2 **RECORD DRAWING**

COVER SHEET
APS ATRISCO HERITAGE ACADEMY HIGH SCHOOL
TEMPORARY OFFSITE POND

GRADING SITE PLAN
APS ATRISCO HERITAGE ACADEMY HIGH SCHOOL
TEMPORARY OFFSITE POND

CONSTRUCTION DETAIL
APS ATRISCO HERITAGE ACADEMY HIGH SCHOOL
TEMPORARY OFFSITE POND

A1 OFFSITE GRADING PLAN

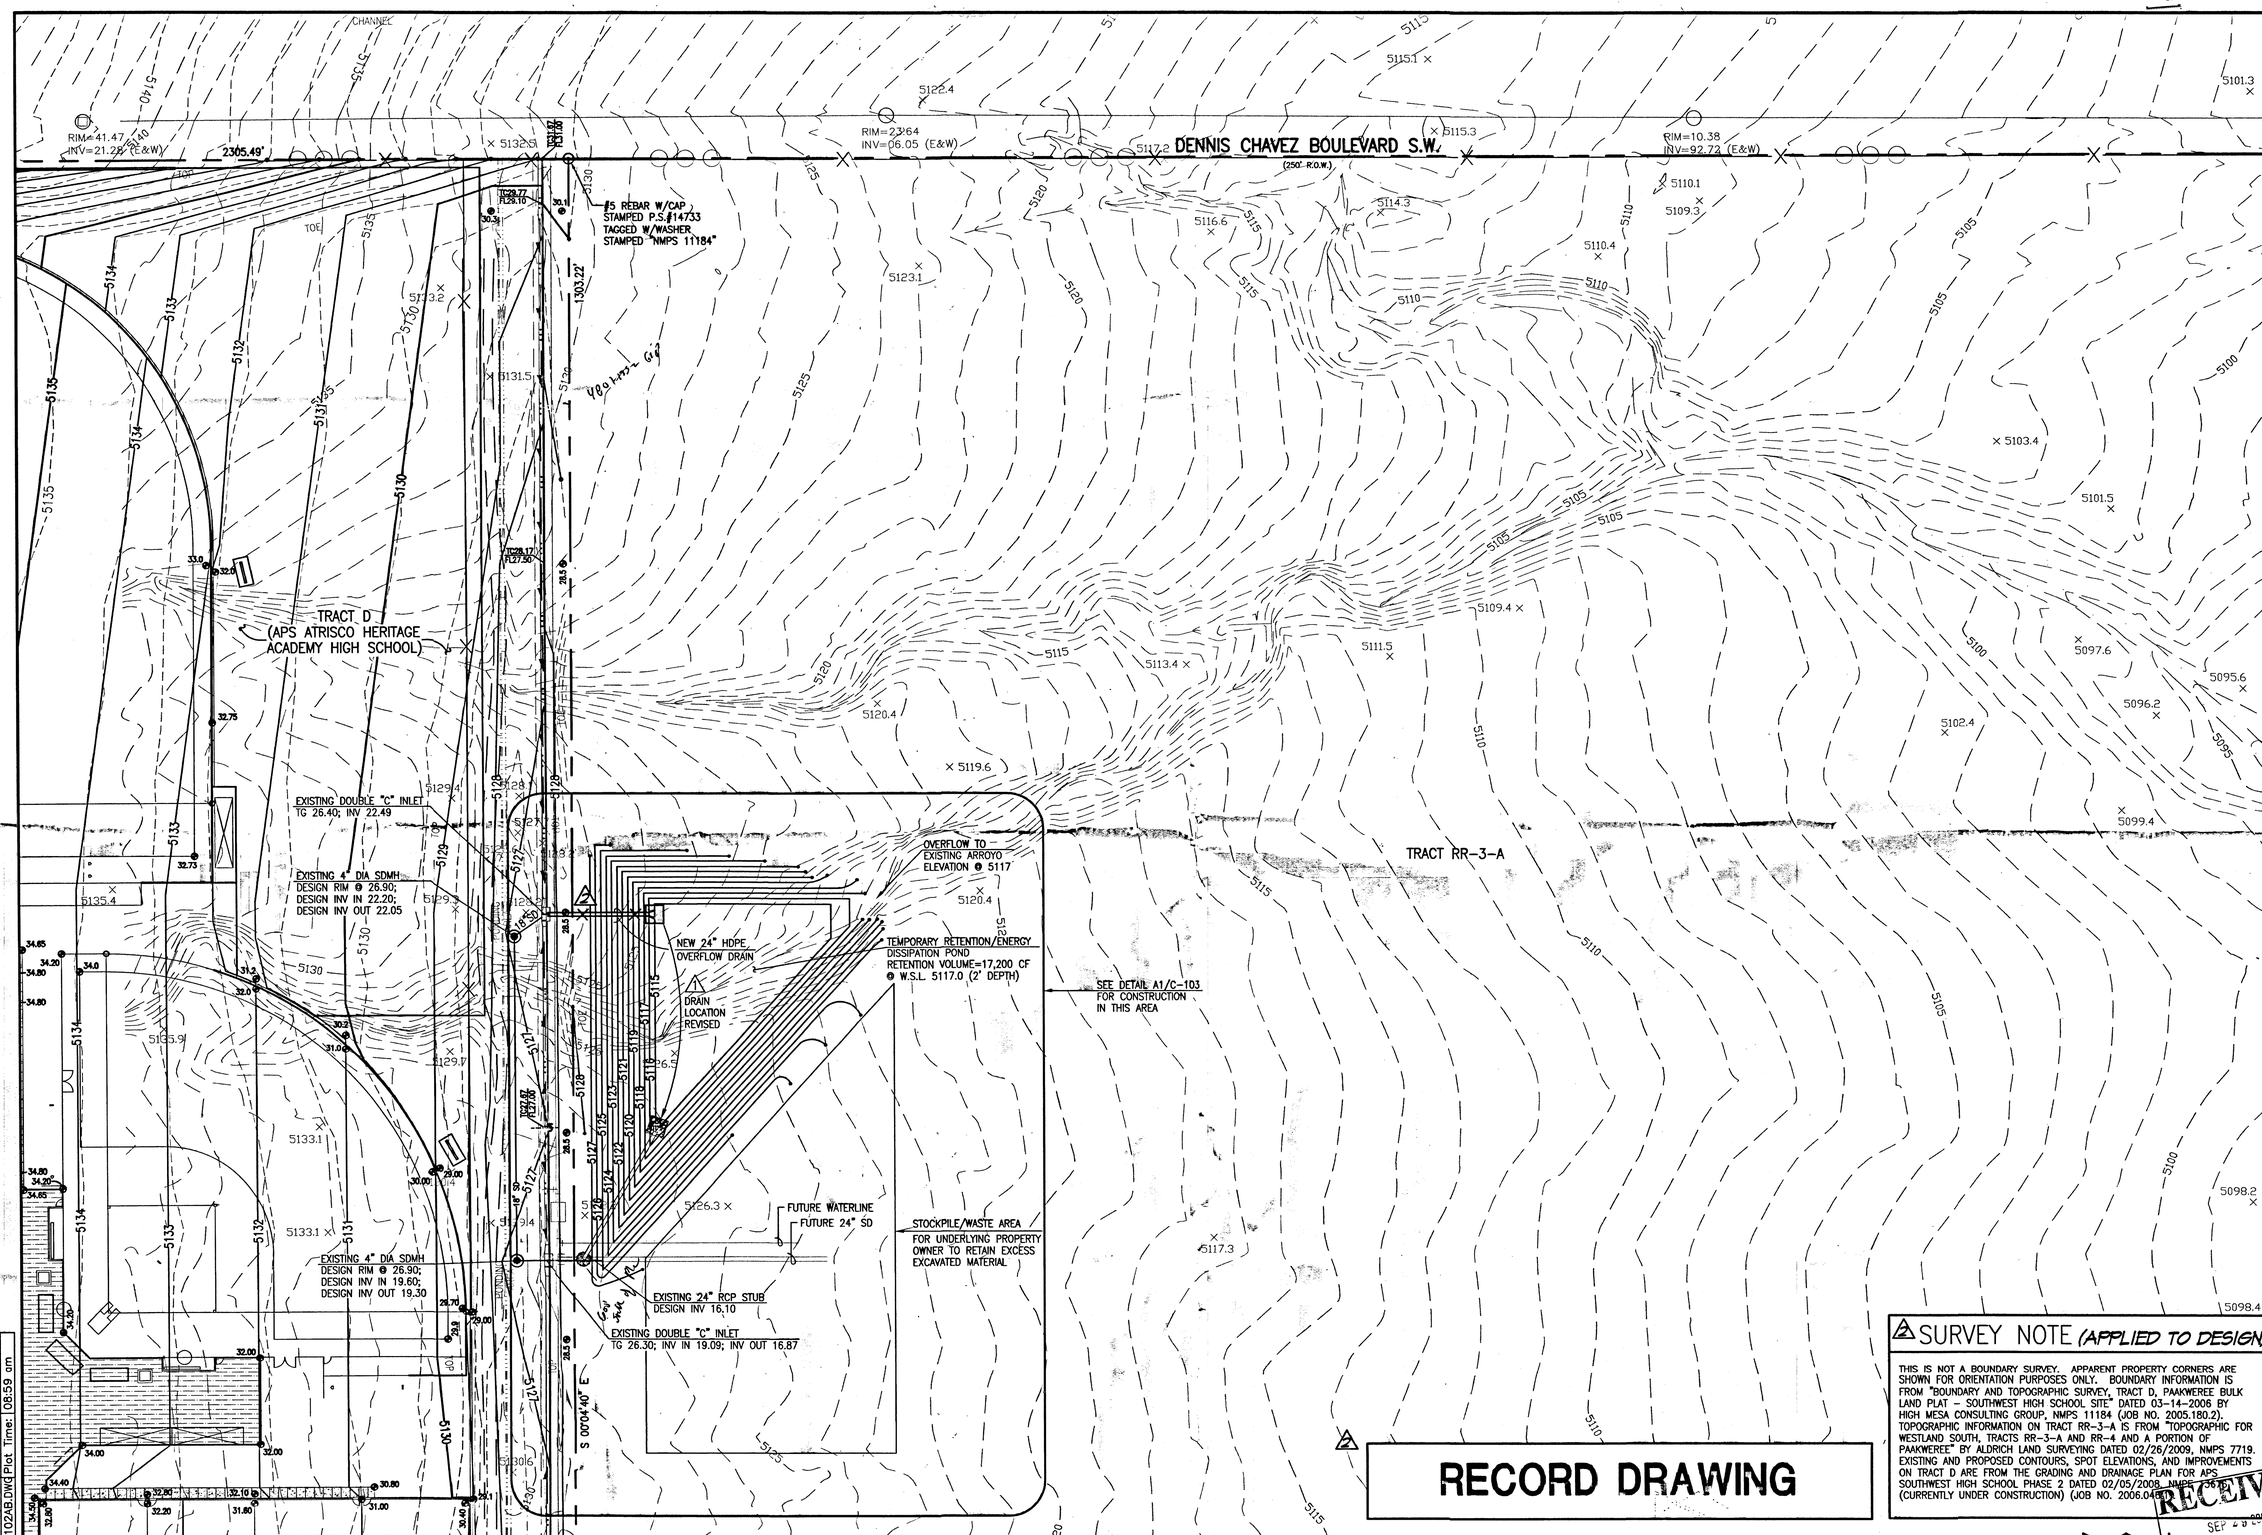
1) THE LOCATION OF THE PIPE CONNECTION WAS ADJUSTED IN RESPONSE TO A VERTICAL CONFLICT WITH AN EXISTING WATER LINE. THE REVISED LOCATION IS SHOWN ON THE PLAN.

NO.	DATE	BY	REVISIONS
1	08/09	G.M.	REVISE DRAIN LOCATION
2		G.M.	RECORD DRAWING

A1 CONSTRUCTION DETAIL

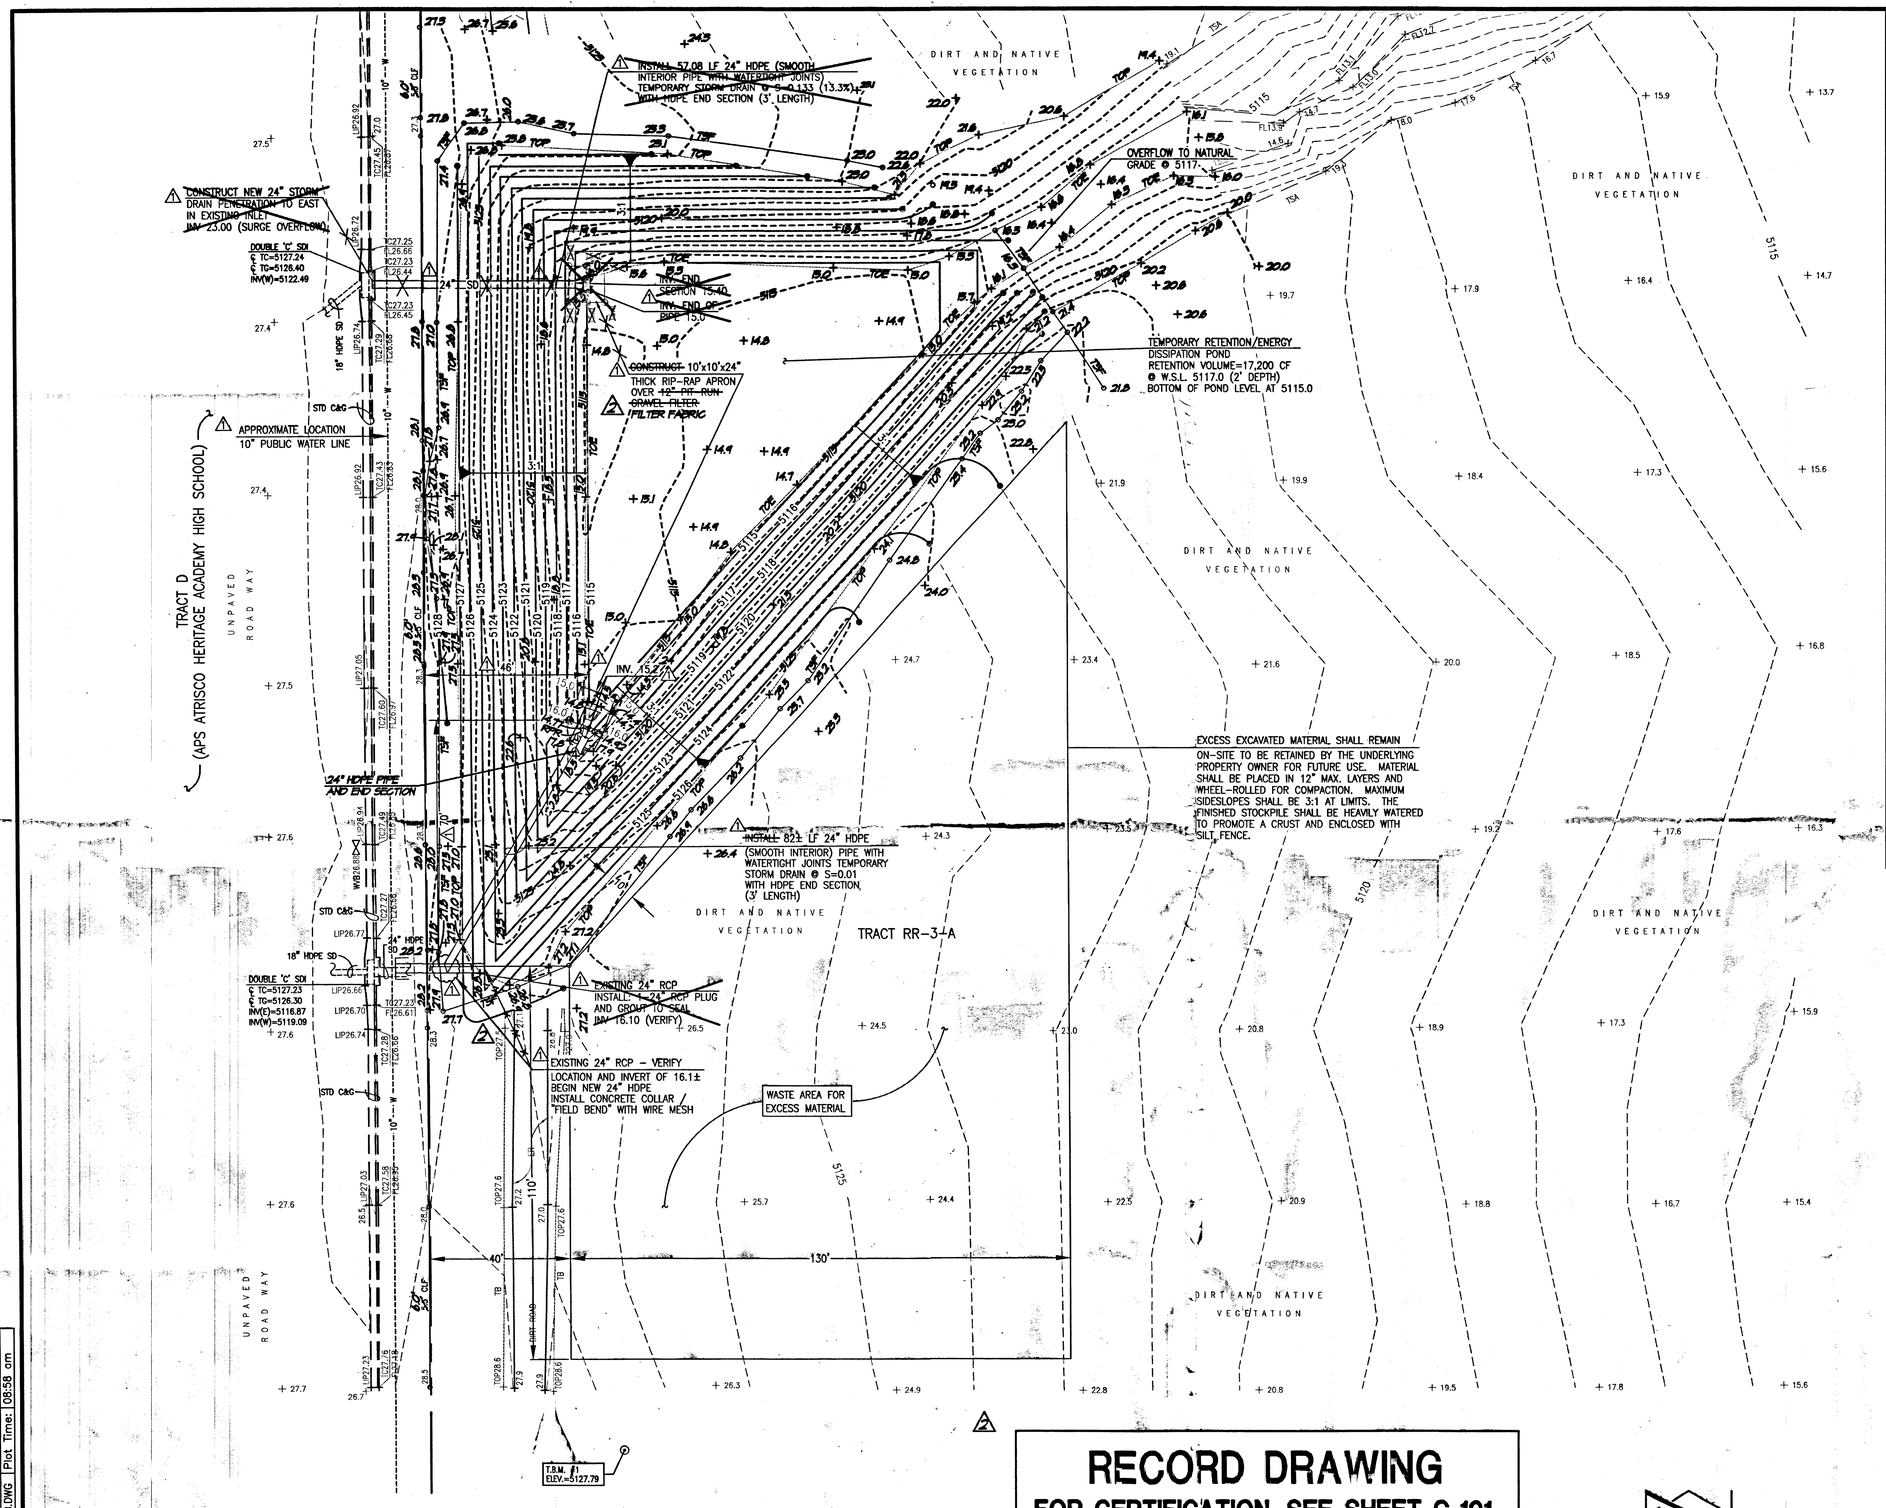
2 AS-BUILT VOLUME @ ELEVATION 5117 = 17,051 CF > V_{100} (EXCEEDS REQUIREMENTS)

NO.	DATE	BY	REVISIONS
1	08/09	G.M.	REVISED DESIGN
2	09/09	G.M.	RECORD DRAWING AND CERTIFICATION
